QUESTIONS AND ANSWERS TO RFI's

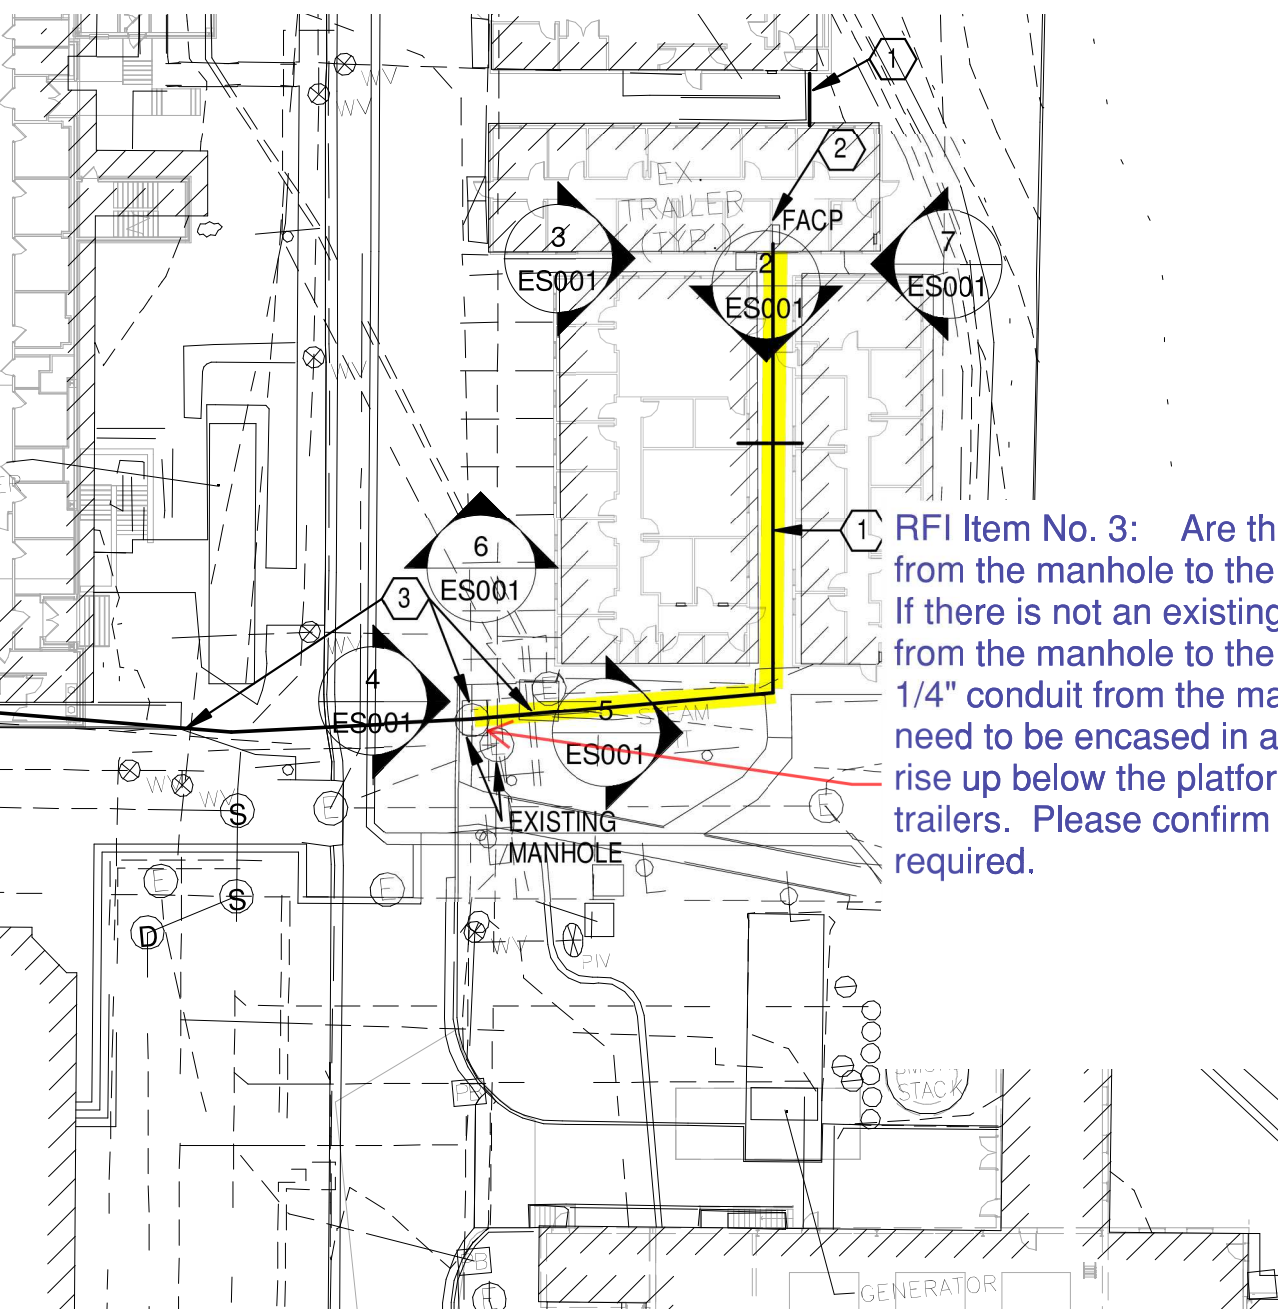
3. **Q:** Are there any ductbanks from the manhole to the trailers? Please see attached sketch-A. If there is not an existing ductbank in place from the manhole to the trailers will the 1-1/4" conduit from the manhole need to be encased in a trench and then rise up below the platform between the trailers. Please confirm trench details if required.

RFI Item No. 3: Are there any ductbanks from the manhole to the trailers. If there is not an existing ductbank in place from the manhole to the trailers will the 1 1/4" conduit from the manhole need to be encased in a trench and then rise up below the platform between the trailers. Please confirm trench details if required.

A: Provide 2-2" PVC conduit concrete encase 30" below grade from trailer to manhole near street.
